March 24, 2023

**NOTICE OF ADDENDUM
ADDENDUM NO. 2**

**CONTRACT NO. 9226, PROJECT NO. 12393
Phase 2 CCB City Office Remodels, First and Fifth Floors**

SCALE	
PROJECT NUMBER	210101
SET TYPE	PLAN REVIEW
DATE ISSUED	12/22/2022
SHEET NUMBER	M502N

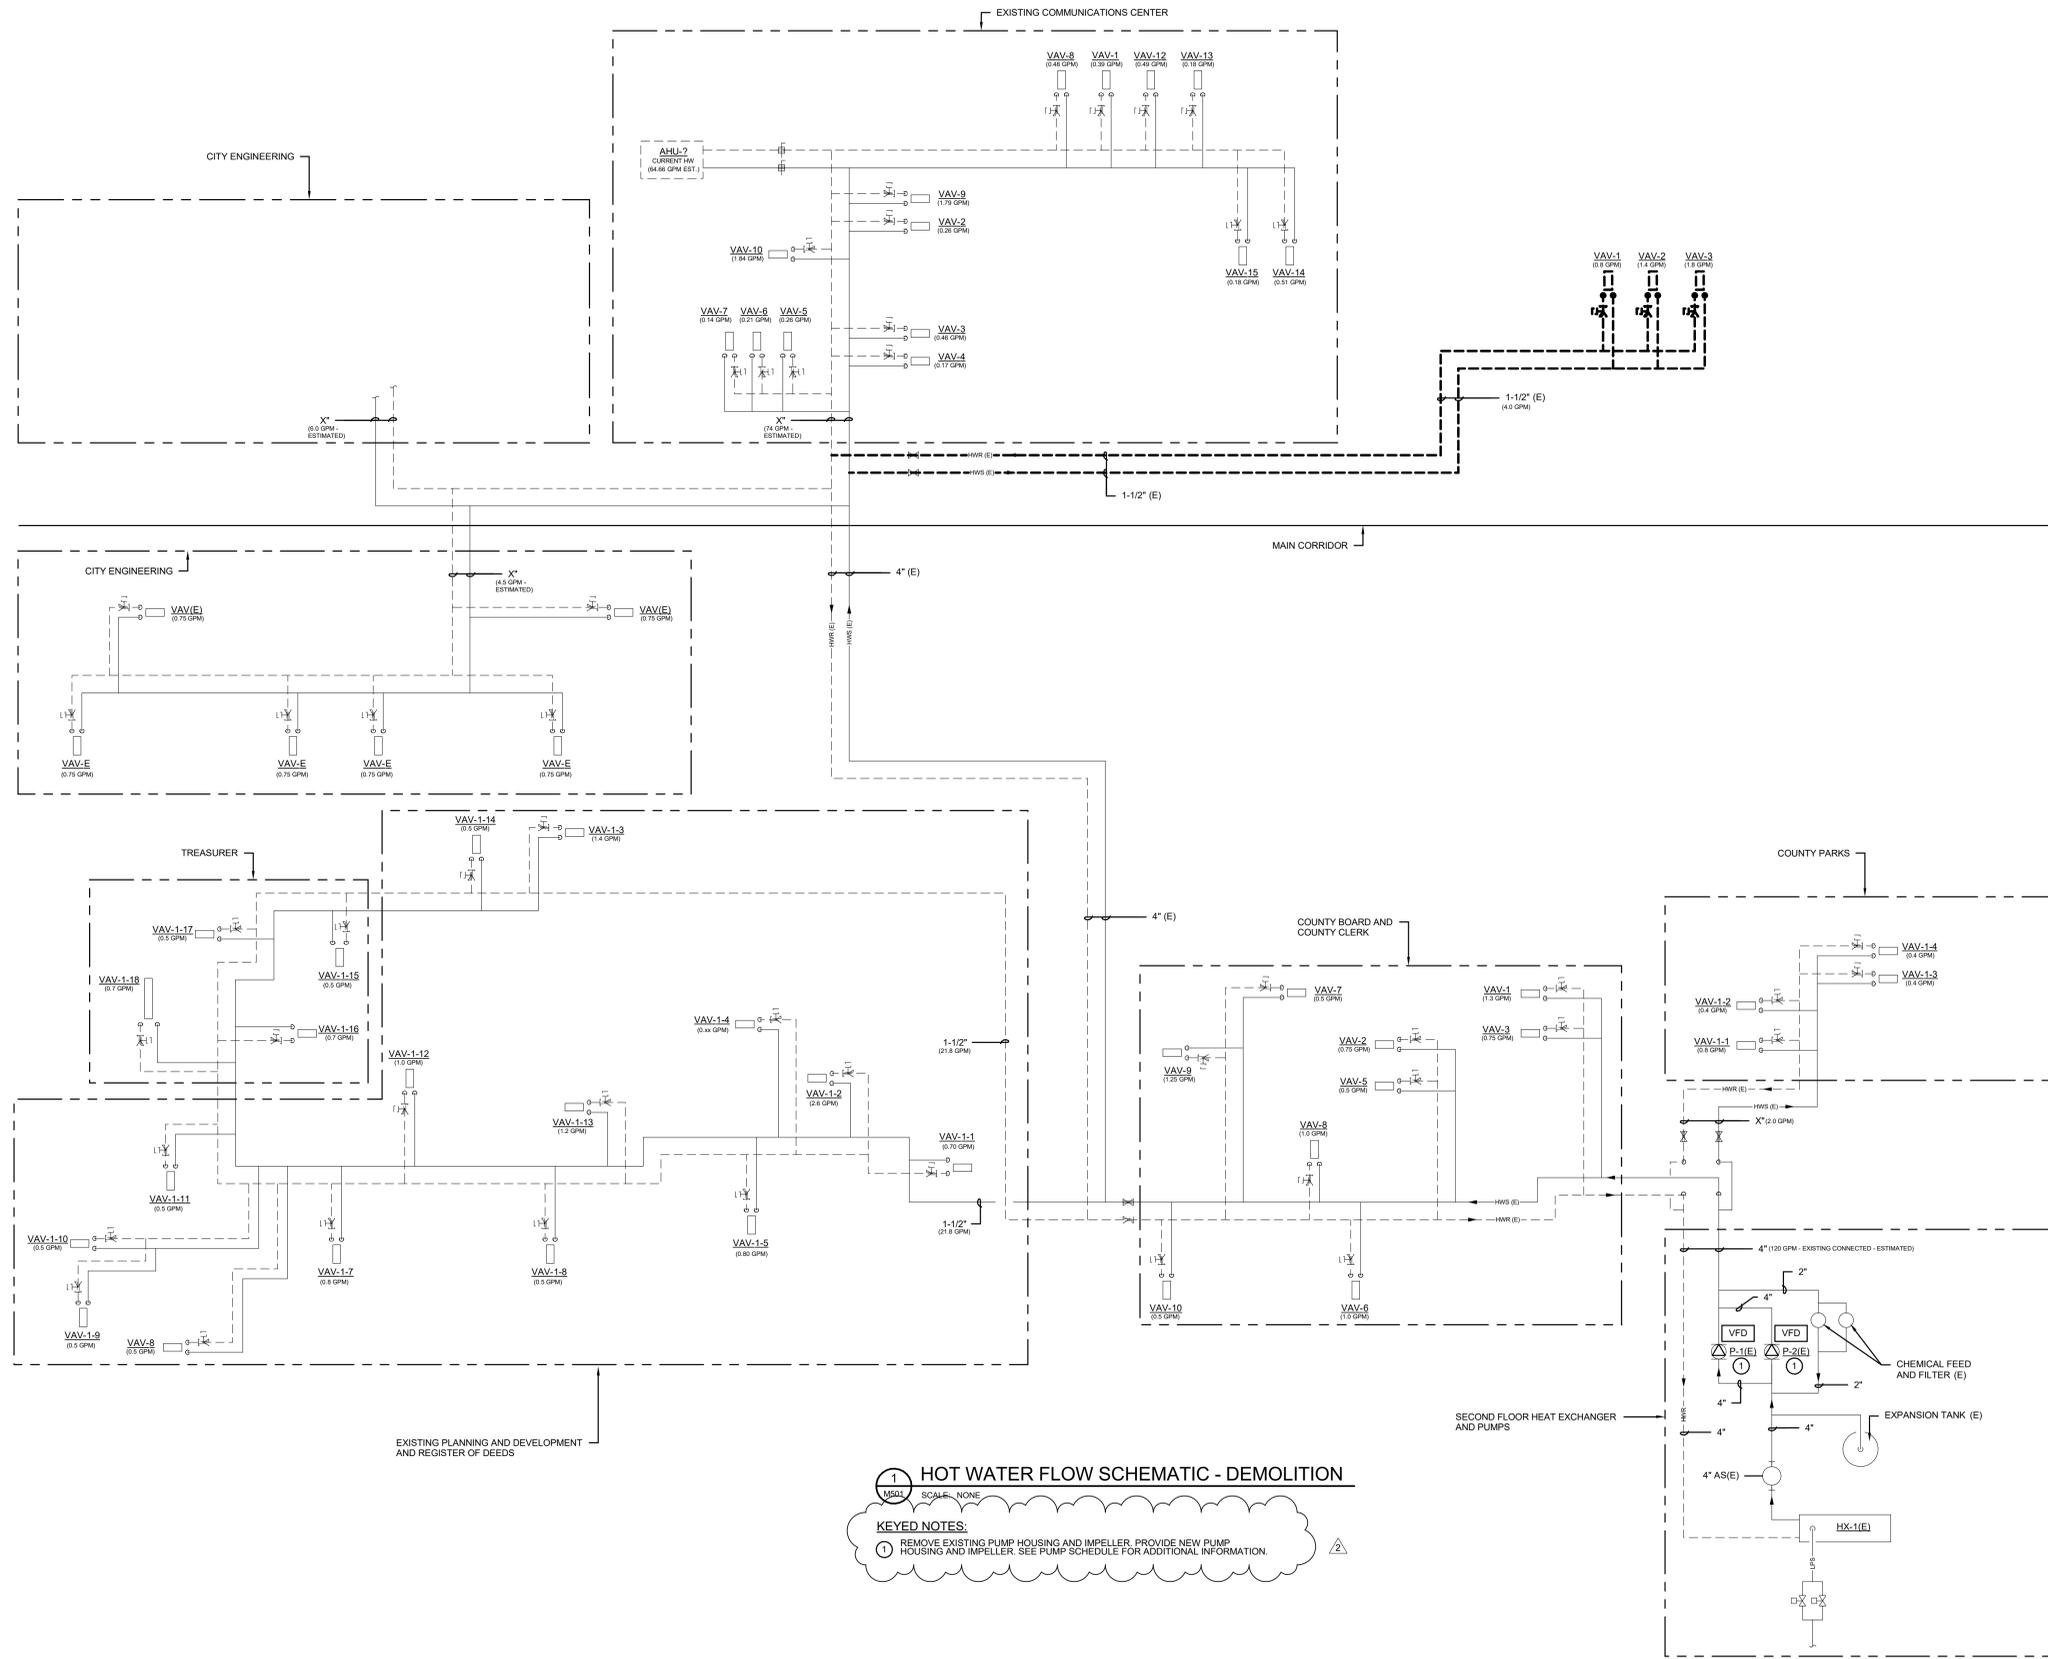
4. Sheet M502N – Revise keyed note 1 as shown. Provide new pump housing and impeller. Existing pump motor to be reused.
5. Sheet M801 – Pump Schedule: Updated pump schedule to reflect replacement of both the housings and impellers on existing pumps P-1 and P-2. VAV Terminal Unit with Reheat Schedule: Updated the existing air handler system number associated with each VAV terminal Unit. Control Damper Schedule: Updated the existing air handler system number associated with each new control damper/AFMS.

1 HOT WATER FLOW SCHEMATIC - NEW WORK
SCALE: NONE
KEYED NOTES:
1 PROVIDE NEW PUMP HOUSING AND IMPELLER. EXISTING MOTOR TO REMAIN. SEE PUMP SCHEDULE FOR ADDITIONAL INFORMATION.
